Product Change Notification

Date Issued :	May 19, 2023	PCN Number :	513631
Reason for Change :	Change to Product		
Description of Change :	This notification is to inform you about changes that are being made to the part(s) as identified in the list. This change will affect the Fit, Form, Function, or appearance of the parts. Or it may result in a change to the specification or raw material.		
Assessment of Change :	First Article Inspection		
Planned Implementation Date :	November 20, 2023		
Sample Availability Date:	October 13, 2023		
Internal Molex Qualification Date :	October 13, 2023		
Last date to request Samples by Customer :	October 13, 2023		
Traceability Code Markings / Date :	Date code

Before Picture

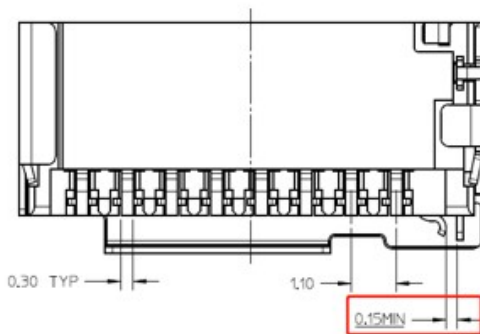
- Per simulated the tolerance analysis to optimize product tolerances

Before change:

After Picture

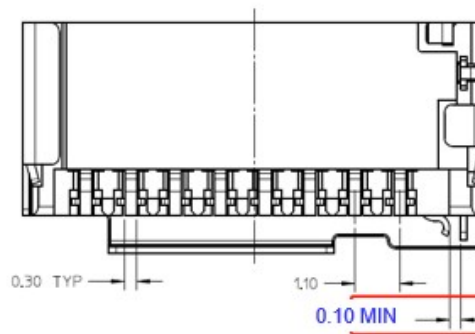
After change:

- Per simulated the tolerance analysis to optimize product tolerances

- Product Impact:
No impact to fit, form or function.
- Part Number Impact:
See attached impacted parts list
